TECHNICAL INFORMATION

SUBJECT	Inlet Manifold Valley Gasket- Leak	03/14/97 12/01/97/NAS
AFFECTED VEHICLES	LP up to 350645 LH up to 664120 LJ up to 709316 and 540078 LD up to 999463

**Revised Intake Manifold Gasket For
1989-97 Rover 4.0L Engines**

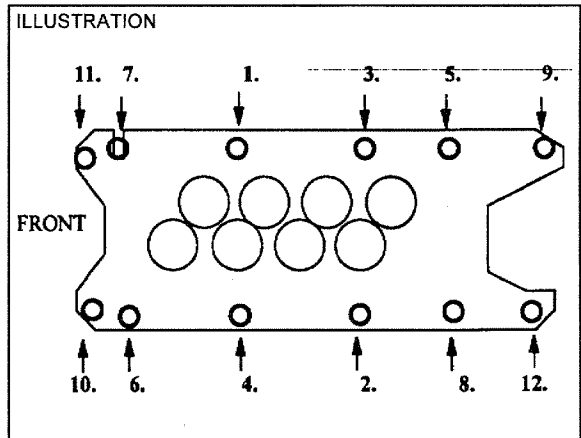
There has been a number of cases of inlet manifold valley gasket leaks. It has been found that the assembly line torque-down procedure does not fully compress the Wolverine gasket material. A two-stage torque-down procedure has been introduced to ensure that full compression is achieved. The new torque-down procedure should be used in addition to installing flat washers beneath the head of each inlet manifold bolt when replacing the inlet manifold gasket. Using the flat washers and the correct torque down procedure will ensure proper compression of the gasket material. Vehicles after the above VIN range have the washer fitted with the correct torque procedure.

In a continuing effort to improve sealing around the inlet manifold, a new inlet manifold gasket and flat washers have been introduced into production. Vehicles built before the change, as indicated by the VIN codes above, can use the new style parts to repair inlet gasket leaks.

The new design gasket (Figure 1) and flat washers are designed to provide improved distribution of clamp load on the inlet manifold to cylinder head joints. As a result of the revised design, the sealing integrity of the joint is greatly improved.

The gasket design change can be easily identified as a change in the shape of the gasket around each inlet and coolant port opening. The installation of the new parts requires the correct torque procedure and must be followed with the new style gasket and flat washers. Refer to the numbered sequence in Figure 2 below to torque the mounting bolts.

When installing a new inlet manifold gasket, torque the manifold using the following procedures:

1. Tighten clamp bolts at front and rear of gasket to **5 Nm-10 Nm (4-7 lb.ft.)**.

CAUTION: A flat washer must be used beneath each bolt head to ensure correct pressure is being applied.

2. Tighten the 12 inlet manifold/cylinder head bolts to **30 Nm (21 lbf. ft.)**
3. Allow gasket to bed in for at least 5 minutes.
4. Refer to the illustration for correct bolt tightening sequence and tighten all inlet manifold/cylinder head bolts to **47-54 Nm (35-40 lbf.ft.)** using a standard torque wrench.
5. Tighten clamp bolts at front and rear of gasket to **14-20 Nm (10-15 lbf.ft.)**.
6. Remove any excess water from valley area.

- 1. Tighten clamp bolts at front and rear of gasket to 4-7 ft/lbs (5 -10 Nm).
CAUTION: A flat washer must be used beneath all 12-bolt heads to ensure correct pressure is being applied.**
- 2. Tighten the twelve intake manifold to cylinder head bolts in sequence (Figure 2) to 21 ft/lbs (30 Nm).**
- 3. Wait! Allow gasket to bed in (set up) for at least 5 minutes.**
- 4. Tighten the twelve intake manifold to cylinder head bolts in sequence (Figure 2) to 35-40 ft/lbs (47-54 Nm) using a standard torque wrench.**
- 5. Tighten clamp bolts at front and rear of gasket to 14-20 Nm (10-15 lb. ft.).**
